DART AEROSPACE LTD	Work Order:	54716
Description: Floor Protector	Part Number:	D3898-1
Inspection Dwg: D3898	Rev: A	Page 1 of 1

D3898-1 FLOOR PROTECTOR (206L)

From: David Shepherd [dshepherd@dartaero.com]
Sent: February 11, 2010 12:39 PM
To: 'Daryl Leger'
Cc: 'Mike Petsche'; cprovencal@dartaero.com; 'Bill Beckett'
Subject: RE: 206-407 Clear polycarbonate floor protectors.

Sent: Tuesday, February 02, 2010 2:25 PM
To: David Shepherd
Cc: Mike Petsche; cprovencal@dartaero.com
Subject: 206-407 Clear polycarbonate floor protectors.

DRAWING NO. D3898 REV. A
SHEET 2 OF 2

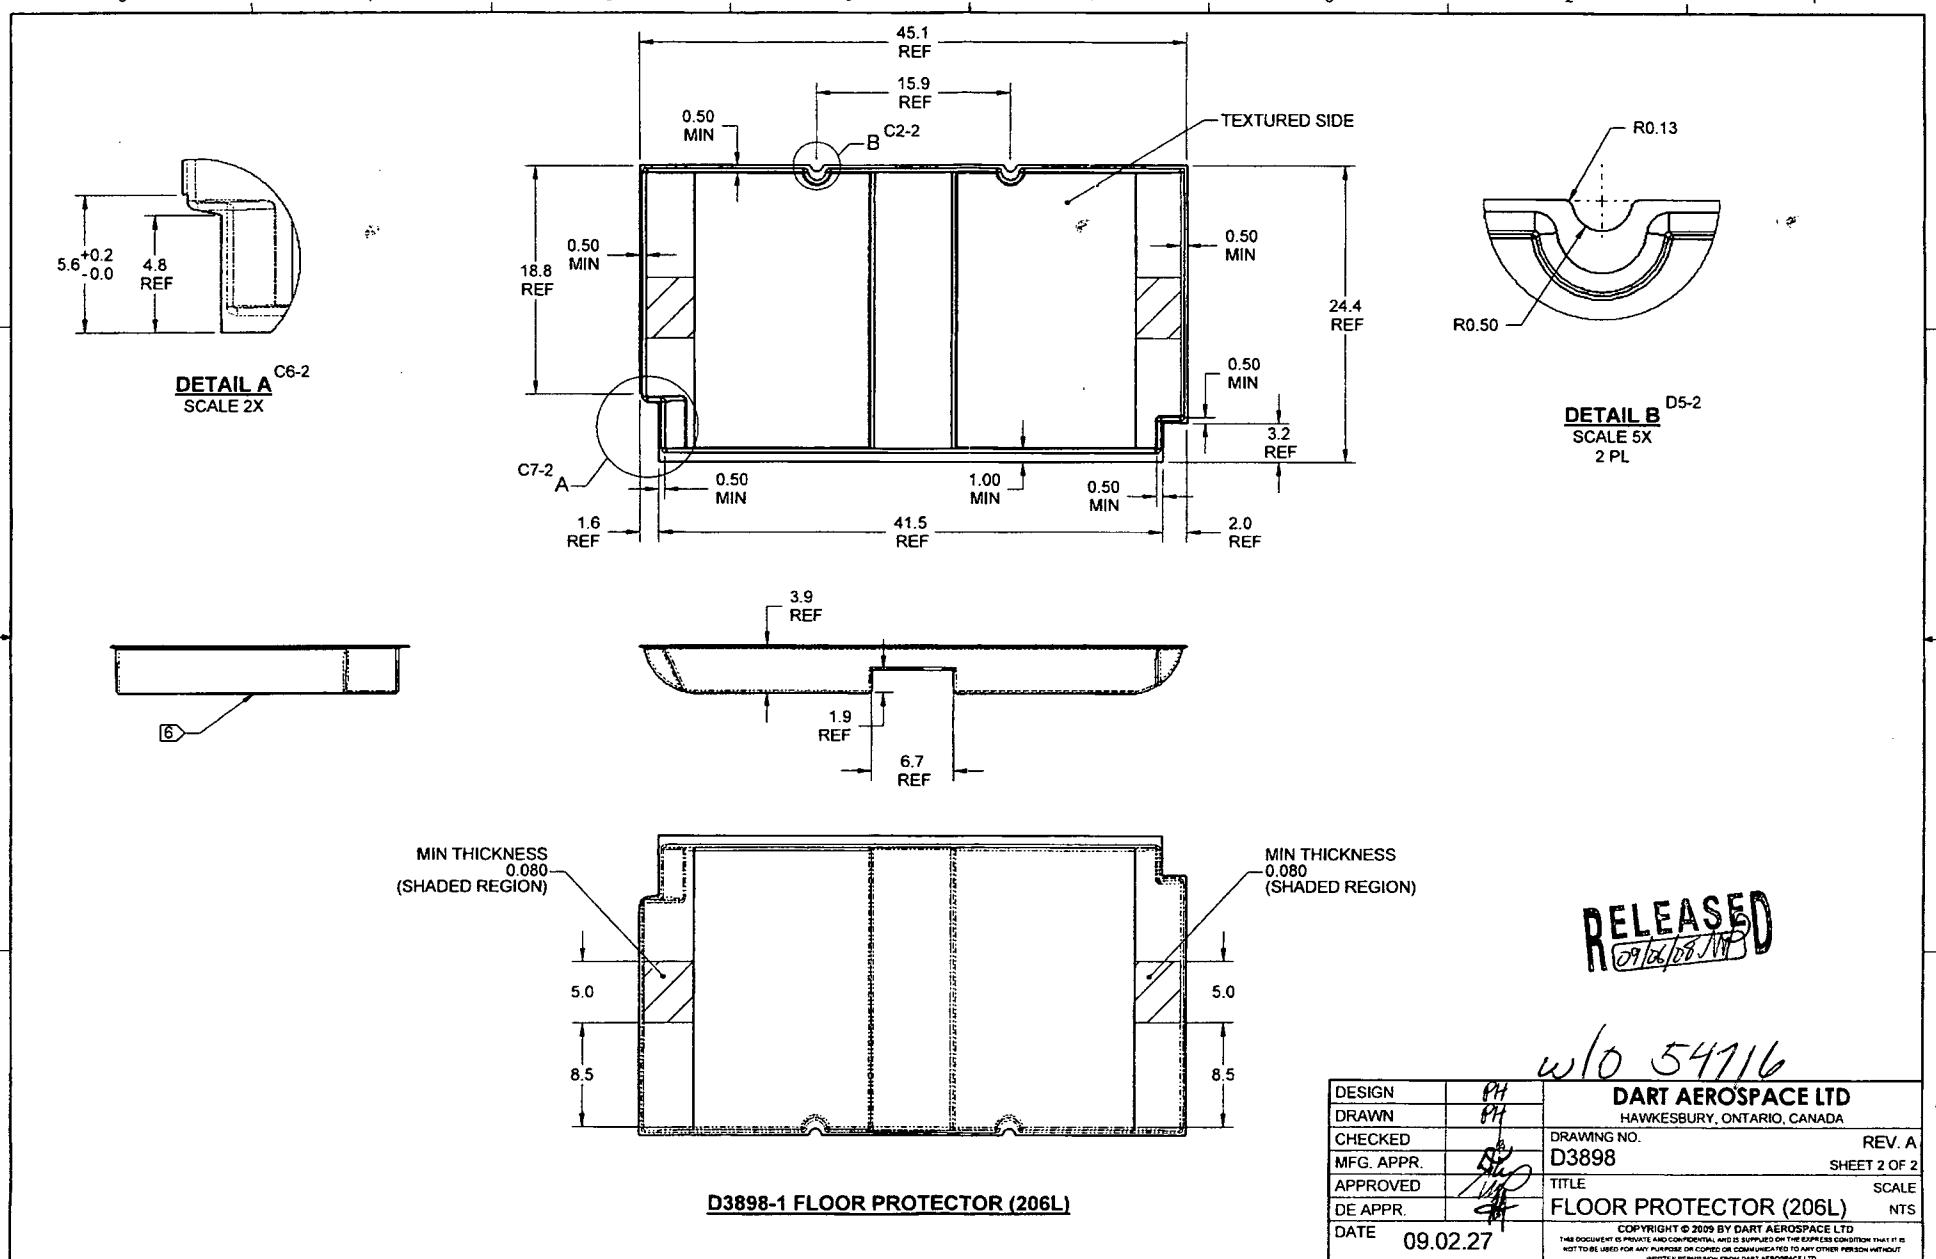
As per our conversation last Friday,
I would like to request that a minimum thickness requirement be changed on the drawings for the rear floor protectors, models 206 and 407.

The reason is that now we are drying our polycarbonate prior to thermoforming.
This drying, evaporates any moisture content in the sheet and eliminates air that can get trapped in the sheet while thermoforming. Trapped air in the sheet can cause unsightly blistering in the sheet and also causes the sheet to expand in thickness because of the air trapped in the sheet. (Remember the expanding polycarbonate rear-facing seats)

The only drawback is that we have difficulty in meeting thickness requirements in some areas. The original test parts were made prior to us understanding the necessity of sheet drying and the material thickness in those test parts, was not near as uniform..

The rear floor protectors (D3875-1, D3898-2 and D3940-1) however call for a minimum thickness of 0.080 at the area of the attachment points. A minimum thickness of 0.050" is called for over the main body for the rest of the rear floor protectors. This is where we are running into a problem.

The recent floor protectors we vacuum formed, have a pretty constant thickness of 0.068" - 0.070" throughout the whole part including the attachment area.

Is it possible to revise the drawings to decrease the thickness requirement of the rear floor protectors at the attachment area to 0.065" without having to re-test.

Based on the argument that the forward protectors only have a thickness requirement of 0.050" at the attachment point, I hope this would be acceptable

Anyways ... enough ranting and raving. To me, the allowable thickness on the forward floor protectors is irrelevant to the rear floor protectors. The loads are based on weight and size of the part, so the loads are considerably higher on the rear floor protectors. What is relevant is the loads that were required and how much load we actually applied during the test.

Per TR-D407-781-5, we were required to pull 20 lb UP, 80 lb FWD, 40 lb SIDE, and 7.5 lb REAR and we actually applied 35 lb UP, 140 lb FWD, 66 lb SIDE, and 30 lb REAR. Bearing/shear stress near the fasteners will be 1:1 dependant on thickness (as opposed to the middle of the part which is in bending). Therefore we have a minimum margin of 65% based on the side loading.

You are requesting a 20% reduction in thickness. Therefore, the parts are acceptable to me

Please update the minimum thickness near the attachment points to be 0.065" (fuck it ... give him 0.060" to be safe) per Daryl's request on D3875-1, D3898-1 (there is no -2), and D3940-1. The design review should include a rationale similar to the one I have presented above, except that you can eliminate the ranting and raving.
